<b>FOURSQUARE AT STERLING RANCH EAST FILING NO. 1 GRADING AND EROSION CONTROL PLAN</b>			
DESIGNED BY	DLG	SCALE	DATE 11-30-22
DRAWN BY	DLG	(H) 1"=	SHEET 2 OF 29
CHECKED BY	(V) 1"=	JOB NO.	1183.23

FOURSQUARE AT STERLING RANCH EAST FILING NO. 1  
GRADING AND EROSION CONTROL PLAN  
DESIGNED BY DLG SCALE DATE 03-10-23  
DRAWN BY DLG (H) 1"= SHEET 3 OF 29  
CHECKED BY (V) 1"= JOB NO. 1183.23

**FOURSQUARE AT STERLING RANCH EAST**  
FILING NO. 1  
STREET IMPROVEMENT PLANS

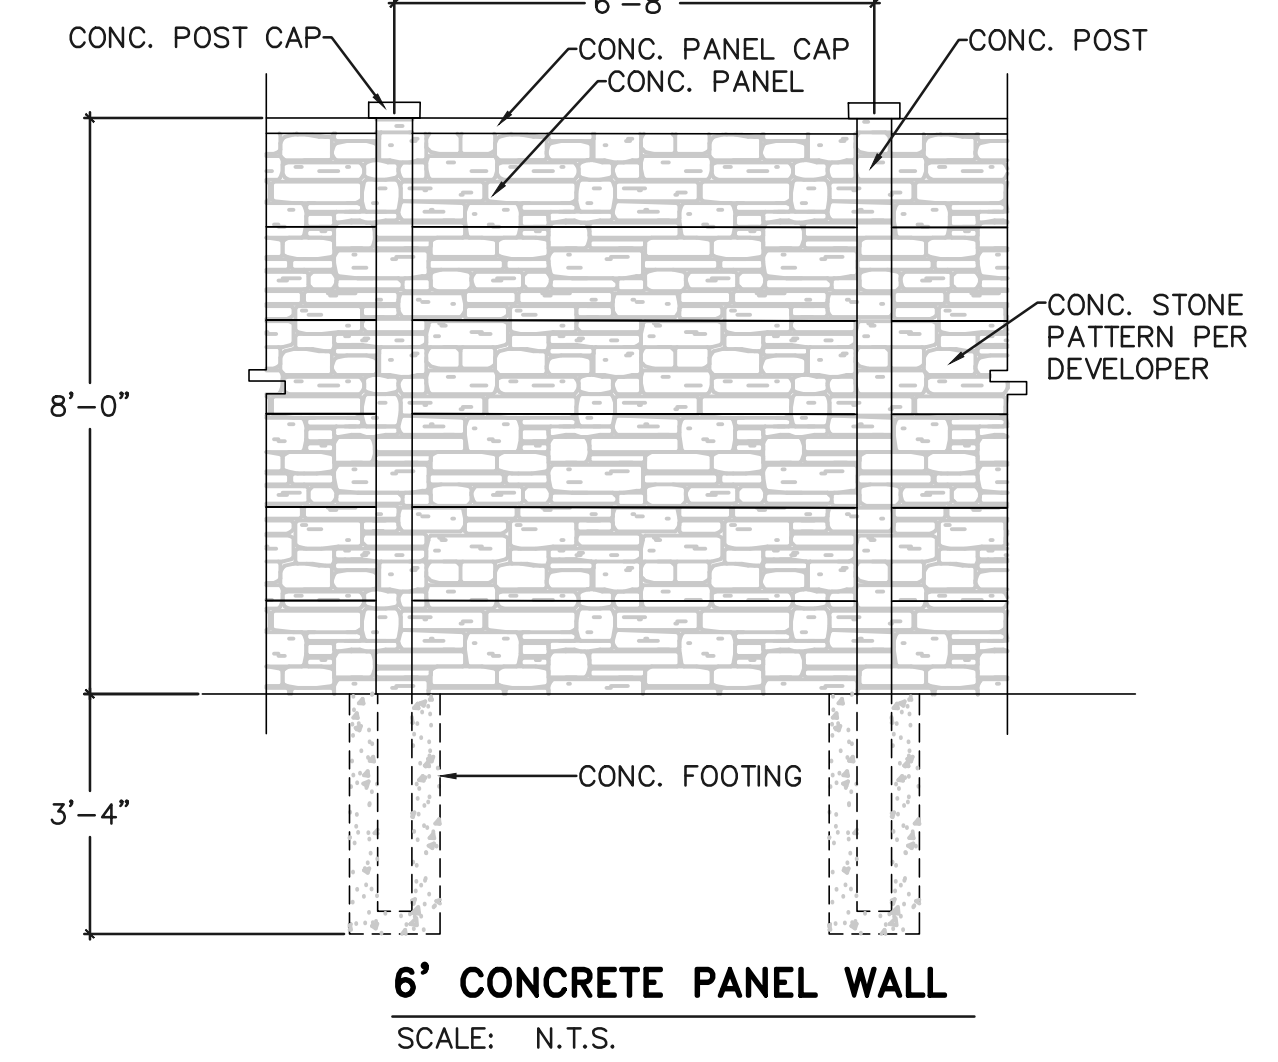
There is a 2019 version of this detail. (CDOT S Standards issued July 31, 2019) It looks like only sheet 1 should be needed with newer sheets.
